Interconnection Facilities Study Report GI-2007-3

**300 MW Wind Generation
Interconnecting at Ault Substation**

**PSCo Transmission Planning
January 6, 2011**

Customer Questions and Comments

Figure 1: Diagram of the GI-2007-3 Interconnection at Ault 230 kV

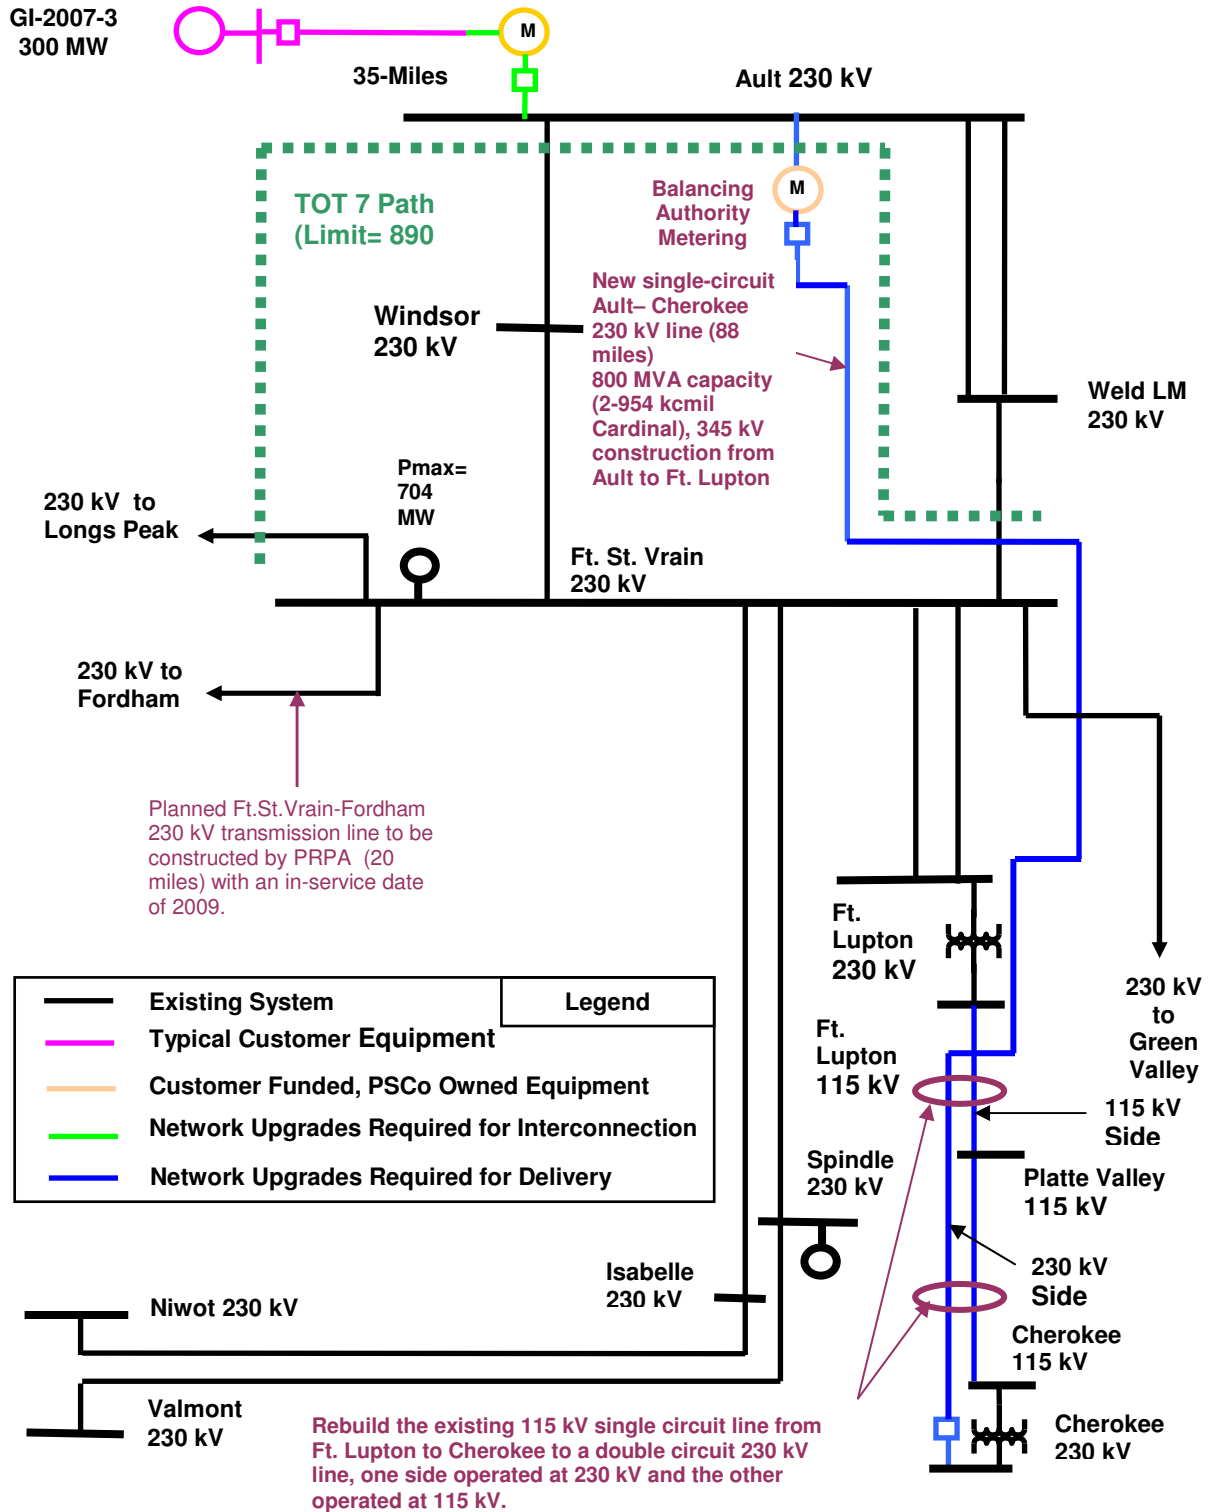
1. Why is 345 kV construction specified on the proposed Ault – Cherokee 230 kV?, Is it necessary?
 - a. 345kV construction is specified in Figure 1 to be consistent with the outlined Ault – Cherokee project scope that was submitted under the Senate Bill – 07 – 100 filing. This scope will be further clarified in the CPCN filing with the Colorado PUC. In order for the Customer to interconnect at the Ault substation, the Ault – Cherokee 230 kV line will still be a necessary Network Upgrade, and the tower construction should have no direct impact on the Ault – Cherokee 230kV line itself. The customer will not be paying for the Ault – Cherokee 230 kV line if PSCo completes the line as a SB – 07 – 100 project.
